Access Compliance Report Public Rights-of-Way (Curb Ramps)

Intersection ID: 10028232Main Street: HEBRON_COMMERCE_DRCross Street: N/ALocation:NEADA ID: 650A431829FBRamp Type: ParaDiagInitial Pass/Fail: FailOverall Compliance: NoSeverity Score:35

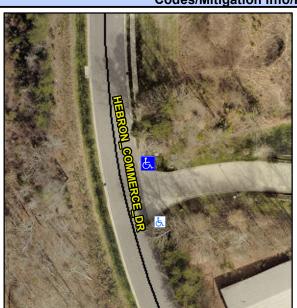
R304.5.1, R304.3.2, R304.5.3

Field Measurements/Component Compliance					
Compliance Description		Data	Compliance Description		Data
N/A	Ramp Length LT (in)	65.0	N/A	Ramp Length RT (in)	51.0
No	Ramp Width LT (in)	36.0	No	Ramp Width RT (in)	36.0
No	Ramp Slope LT (%)	14.9	Yes	Ramp Slope RT (%)	7.1
No	Ramp XSlope LT (%)	2.1	Yes	Ramp XSlope RT (%)	1.4
N/A	Landing Length (in)	N/A	N/A	DWS Provided?	N/A
N/A	Landing Width (in)	N/A	N/A	DWS Contrast?	N/A
N/A	Landing Slope (%)	N/A	N/A	DWS Length (in)	N/A
N/A	Landing X Slope (%)	N/A	N/A	DWS Full Width?	N/A
N/A	Landing Curb? (Y/N)	N/A	N/A	DWS Offset (in)	N/A
N/A	Shared Landing?	N/A			
N/A	Gutter Ponding?	N/A	N/A	Gutter Slope (%)	N/A
N/A	Gutter Lip Ht (in)	N/A	N/A	Gutter X Slope (%)	N/A
N/A	Painted X Walk1?	No	N/A	Painted X Walk2?	No
	X Walk 1 Direction	To W		X Walk 2 Direction	To S
N/A	X Walk 1 Width (in)	N/A	N/A	X Walk 2 Width (in)	N/A
	X Walk 1 Slope (%)	1.1		X Walk 2 Slope (%)	4.8
	X Walk 1 X Slope (%)	3.6		X Walk 2 X Slope (%)	3.6

Remove & Replace Curb Ramp With Two New Directional Ramps or Equivalent.
